Stage 2D of the Sydney CityGrid Project

SUBMISSIONS RESPONSE AND PREFERRED PROJECT REPORT

FEBRUARY 2011

Figure 3-1 Revised components of the Sydney CityGrid Project

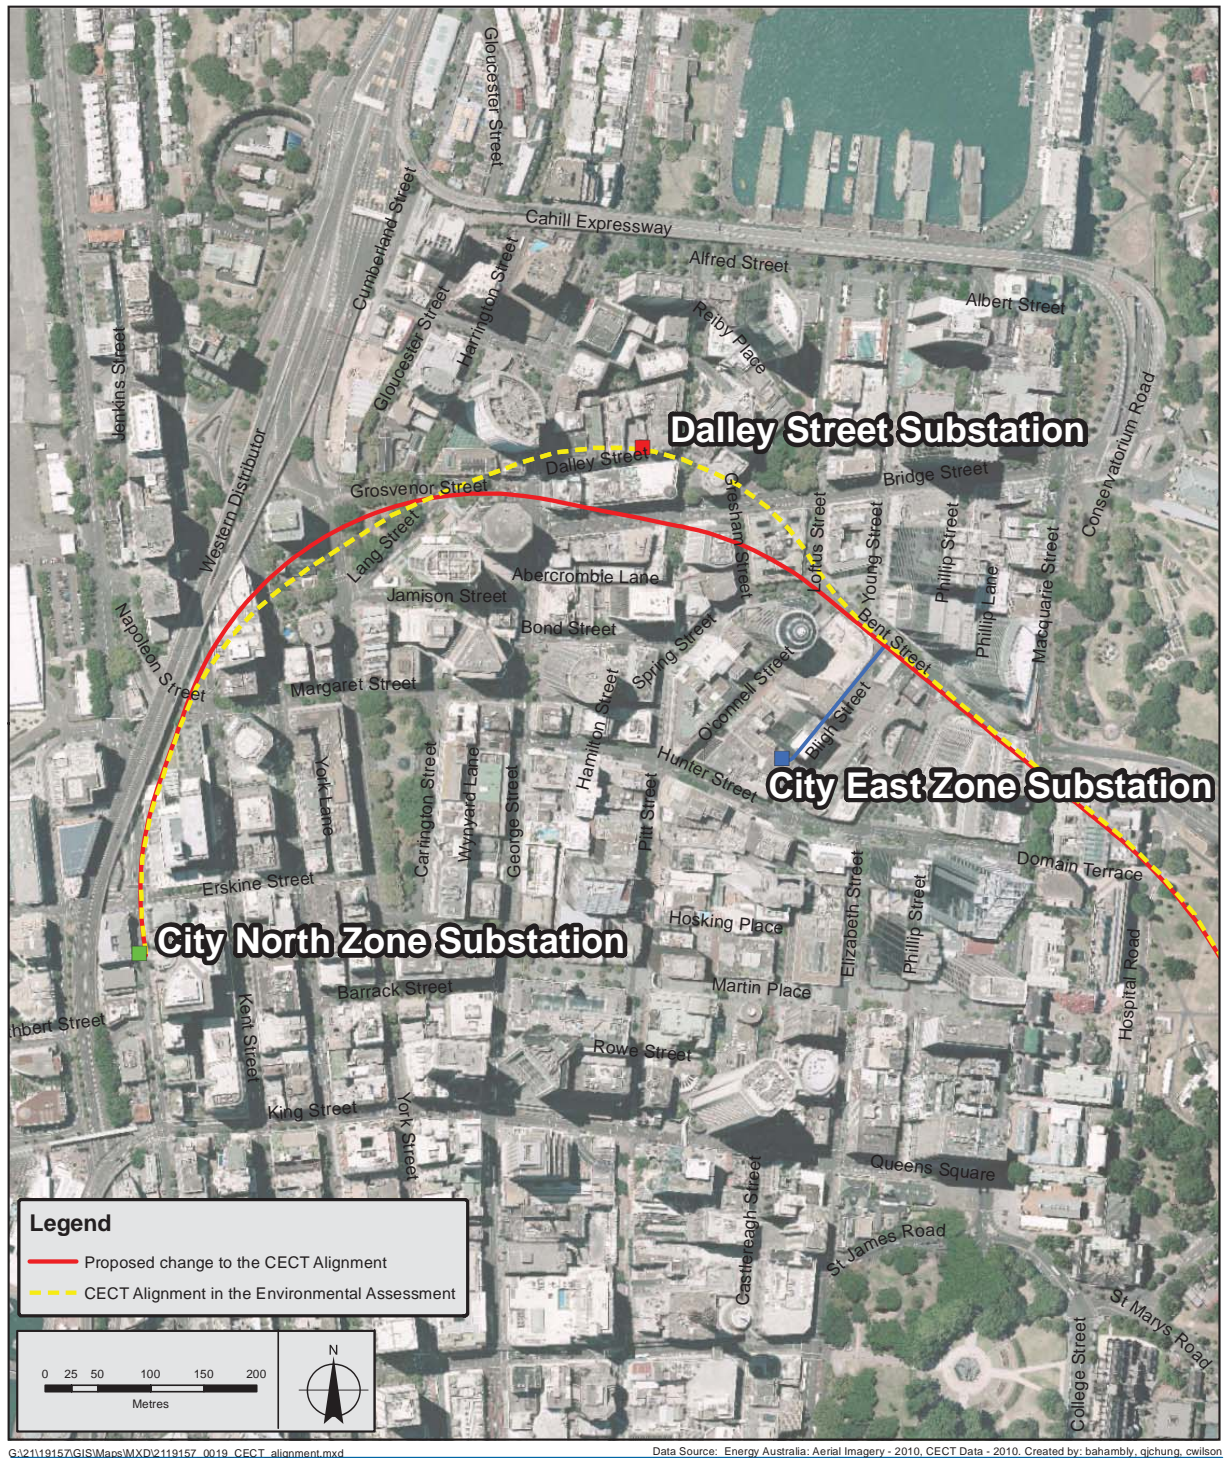
Since exhibition of the Environmental Assessment, Stage 2D has been changed such that approval is no longer sought to refurbish the Dalley Street Zone Substation (refer to Section 3.1) and the alignment of the CECT has been refined to accommodate this change (refer to Figure 3-1 and Section 7).

As discussed in Chapter 3, the project has been modified to remove the Dalley Street shaft and the CECT route has been refined (refer to Figure 3 1). As a result, changes to the traffic arrangements in Dalley Street would not be required.

The alignment of the CECT presented in the Environmental Assessment was developed to pass beneath Dalley Street to minimise the length of the shaft connecting the CECT and the Dalley Street Zone Substation. As the connection to Dalley Street Zone Substation is no longer required, the alignment of the CECT has been refined (refer to Figure 3-1). The section of the CECT that is affected by this change is between the intersection of Loftus Street and Bent Street, and the City North Zone Substation. Drawings of this alignment are located in Appendix A.

The proposed change would result in slightly different noise and vibration impacts to those described in the Environmental Assessment. As the vertical and horizontal alignment has been refined, there have been changes to the distance between the CECT and buildings and underground structures. As a result, the separation distance between the CECT and the nearest buildings and underground structures has reduced by 1 m to 2 m depending on the location. Along the section of the CECT subject to the change in alignment, there is generally 20 m to 30 m separation between the CECT and the nearest underground structures. At the closest point, the CECT is about 11 m from the basement of a building in Kent Street.
